Gibbons Creek Environmental Redevelopment Group, LLC

April 19, 2024

Re: Technical NOD5 New CCR Registration
Gibbons Creek Environmental Redevelopment Group, LLC – Anderson, Grimes County
New Coal Combustion Residuals (CCR) Registration No. CCR113
Industrial Solid Waste Registration No. 32271
EPA Identification No. TXD000751073
Tracking No. 27262344; RN100214550/CN6505860162

32. 2023 Groundwater Report and Attachment S

Gibbons Creek Steam Electric Plant
GCSES Environmental Redevelopment Group
HYDROGEOLOGICAL SECTION PLAN
Anderson, Texas

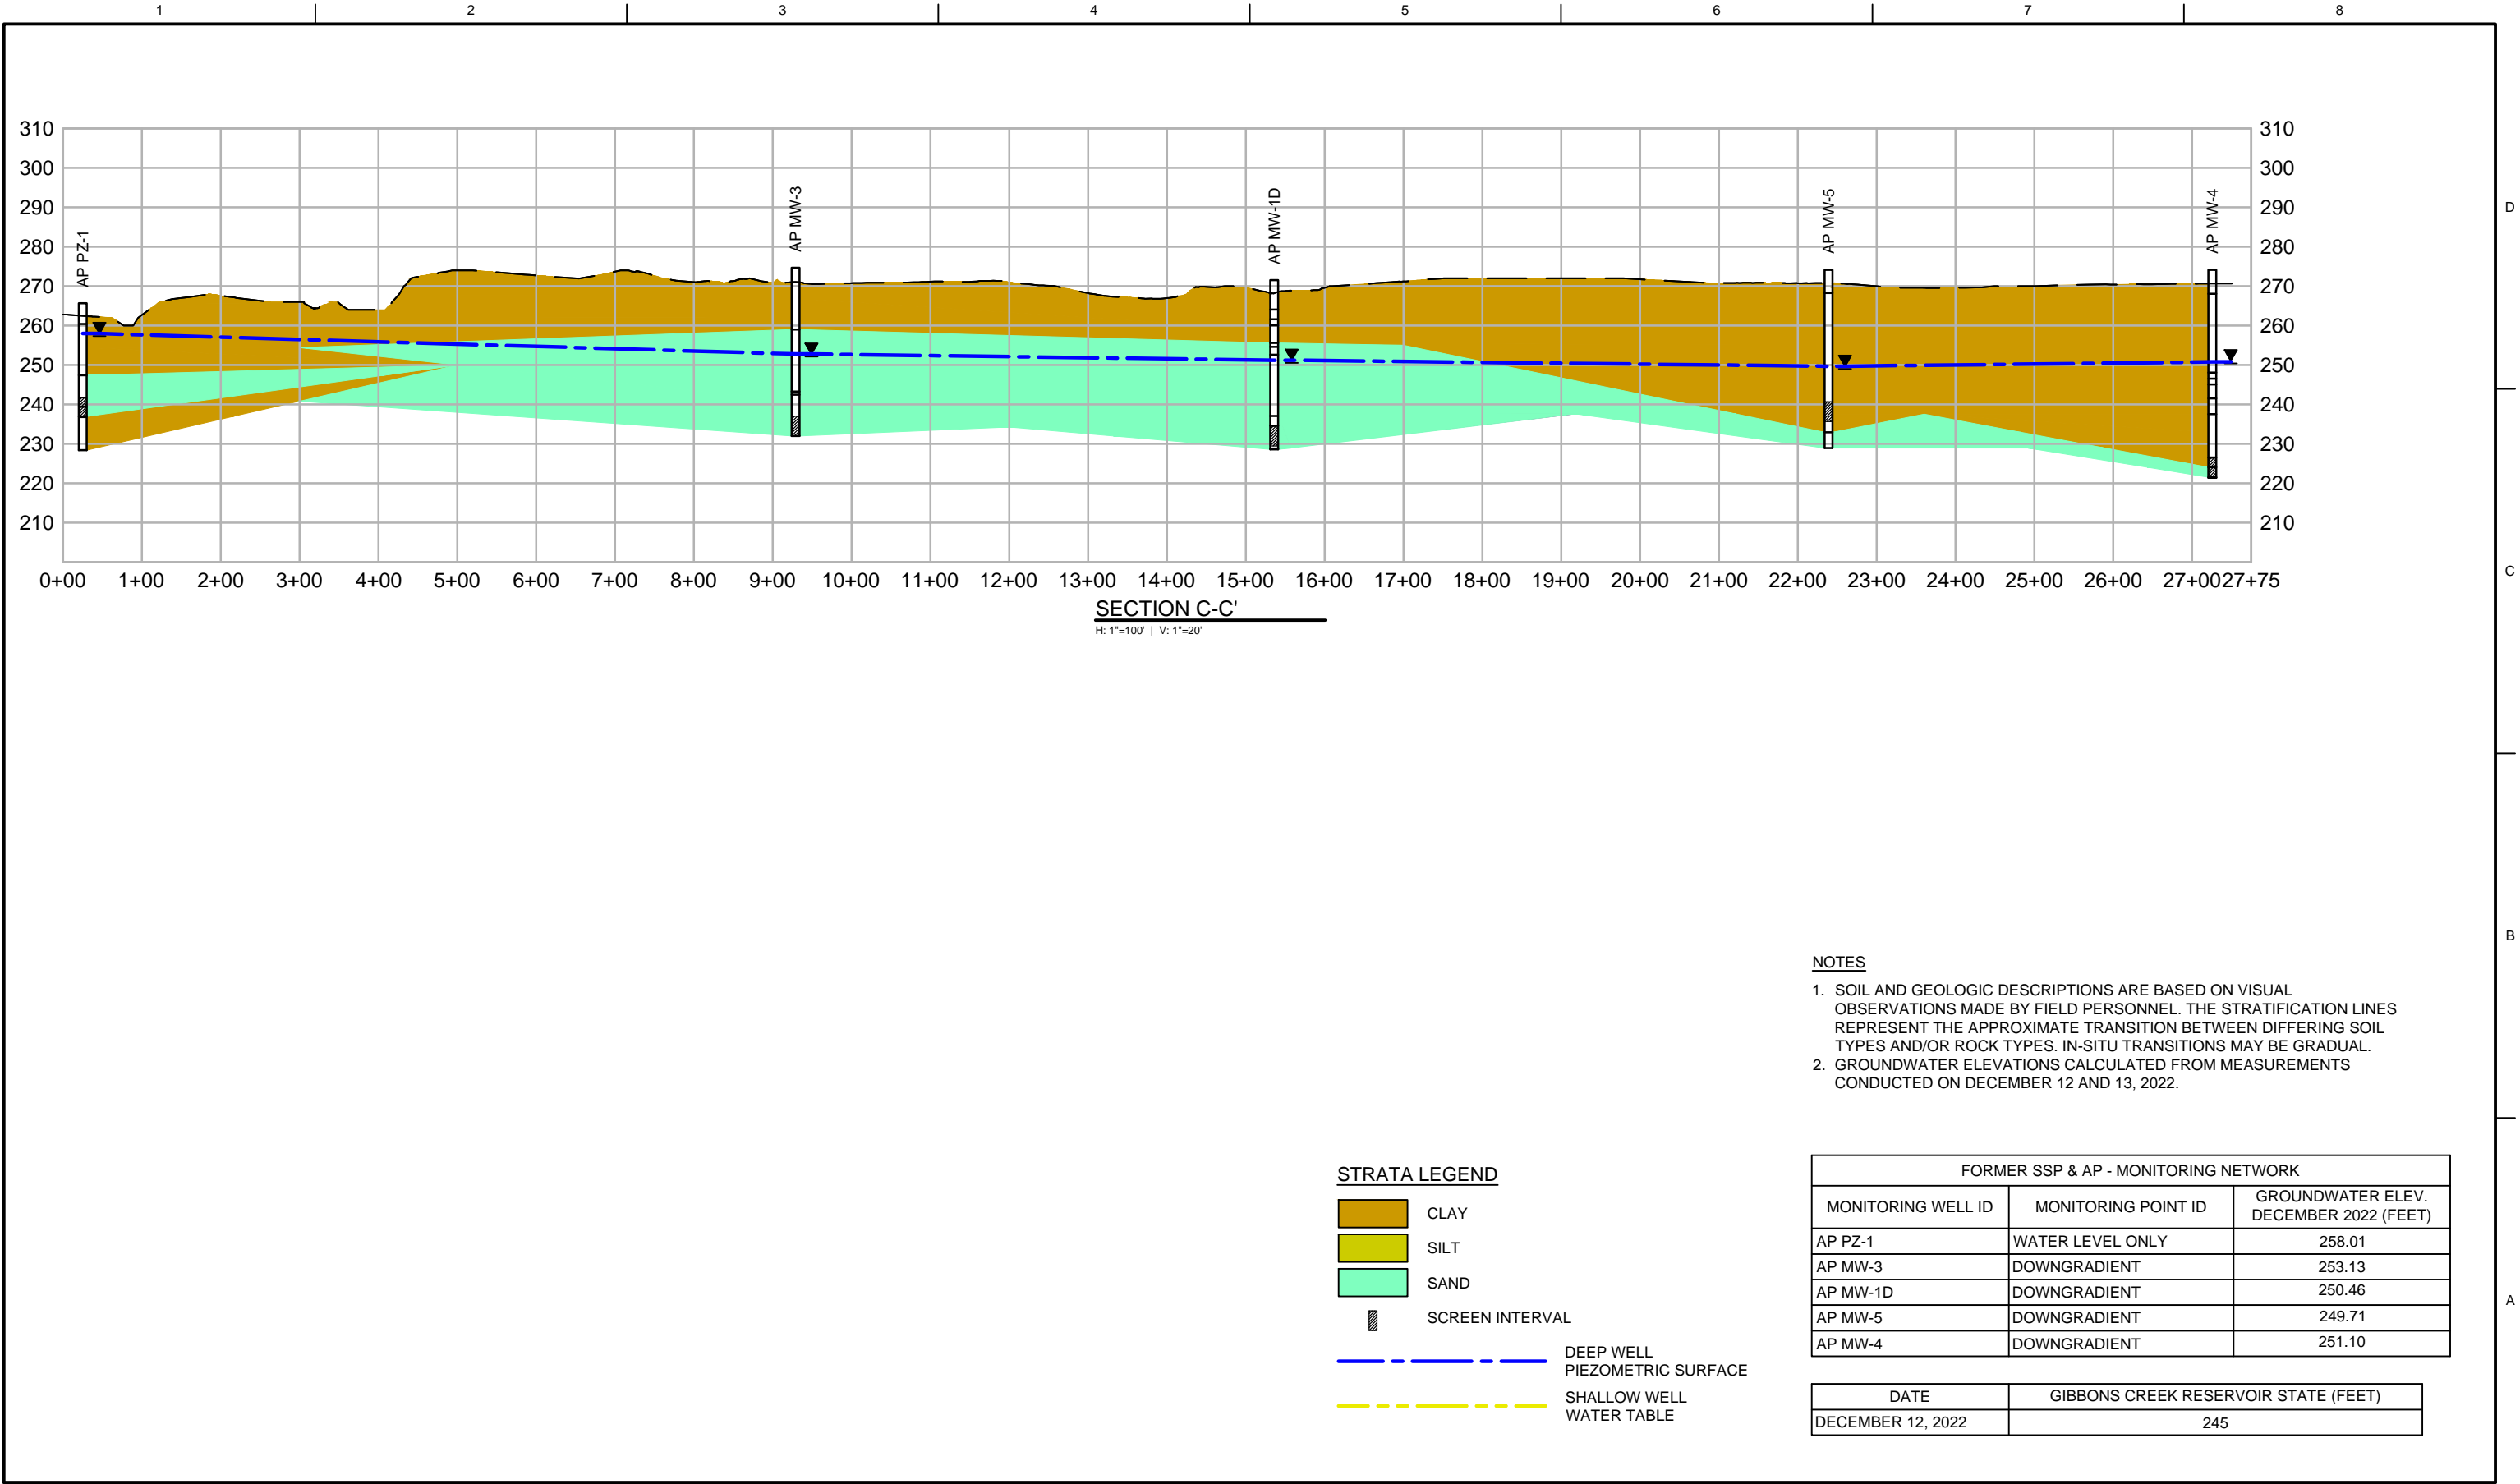
- a) Provide and explanation for how the facility would address two groundwater monitoring systems if the existing monitoring wells for Site F Landfill were not monitoring the same strata (shallow and deeper zones) based on well depths and screen depth intervals. Provide cross sections that clearly show the delineation of two different layers including well location, water level, and well/screen depth for each monitoring well.

Please see “CCR Groundwater Monitoring System” document in Response Item No. 32 Attachment A for the description of the shallow and deeper groundwater networks at the Site F Landfill. Cross sections delineating the two different layers, including well location, water level, and well/screen depth for each monitoring well are included in the attachment.
